RE: **Recall Campaign Launch Notification**
Replace Rear Door Latches
MY19-21 463(G-Class)

Campaign No. 2021060007, July 2021
Revision A July 2021

SUBJECT: **Model G-Class vehicles (463 platform)**
Model year 2021
Replace Rear Door Lock – Code X20 (MY21)

Figure 1

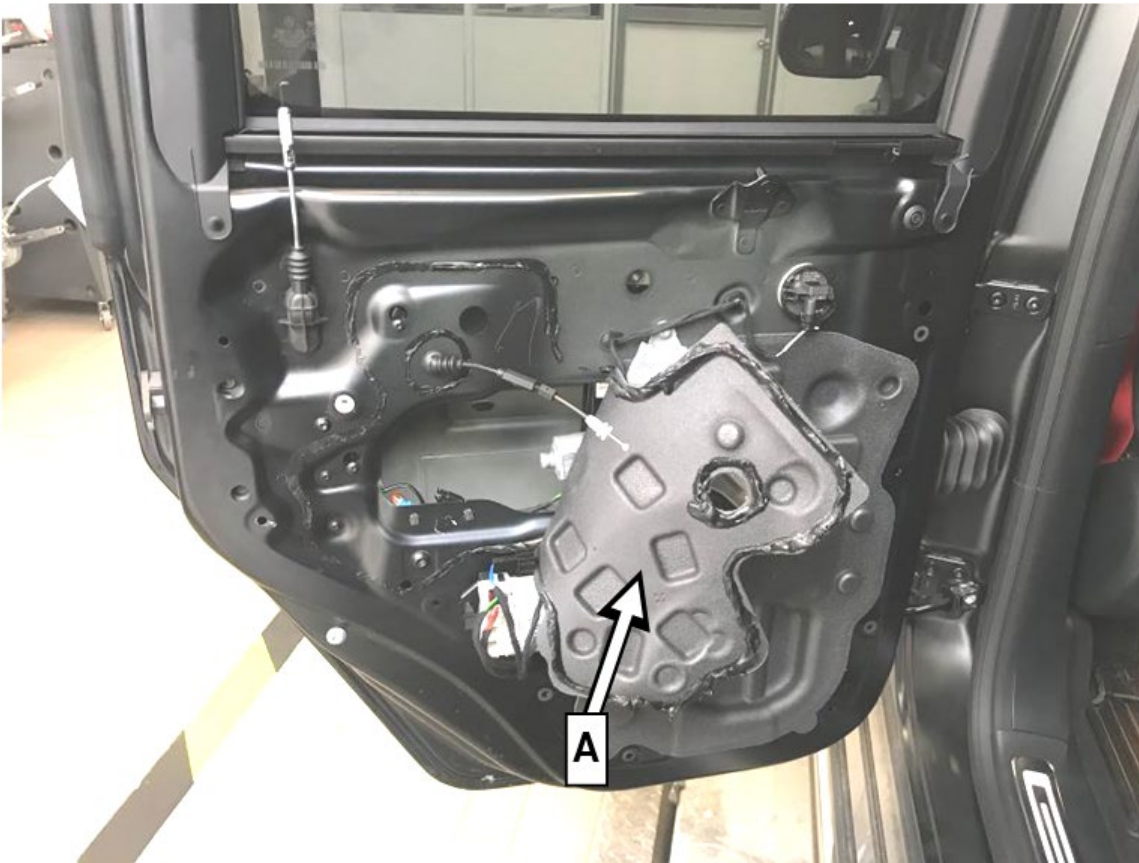
2. **Carefully** pull off door foam sheeting (**A, Figure 1**) from rear doors as shown.

i Door foam sheeting does not have to be completely removed and is reused.

Figure 2

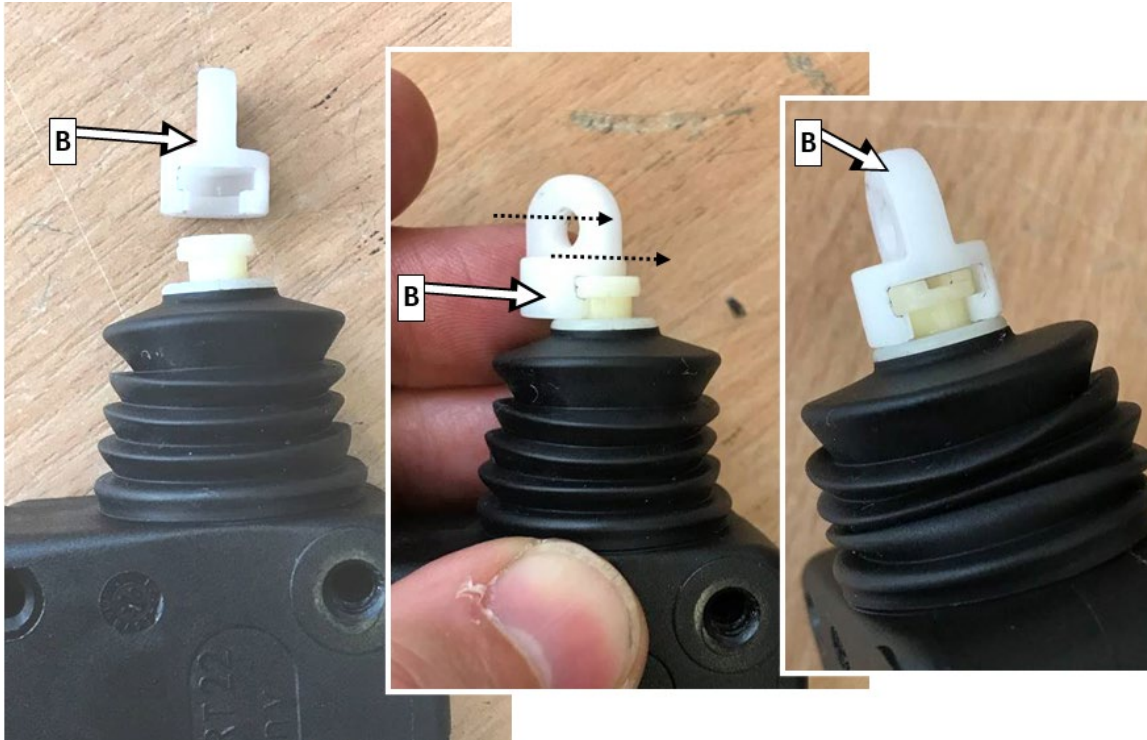
4. Replace mounting clips (**B, Figure 2**) on removed actuator motors for central locking system.

i Mounting clips are included in the parts kit and **must be replaced**.

Figure 3

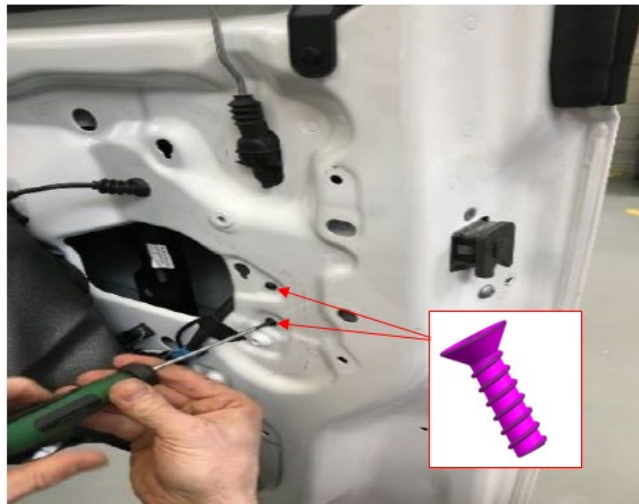
5. Complete unit consisting of door lock, actuator motor of central locking system with release cable, and door locking knob prior to installation and insert into door to assemble.
6. **Mounting screws (Figure 3)** for actuator motor for central locking system **must be replaced** and are included with the parts kit.
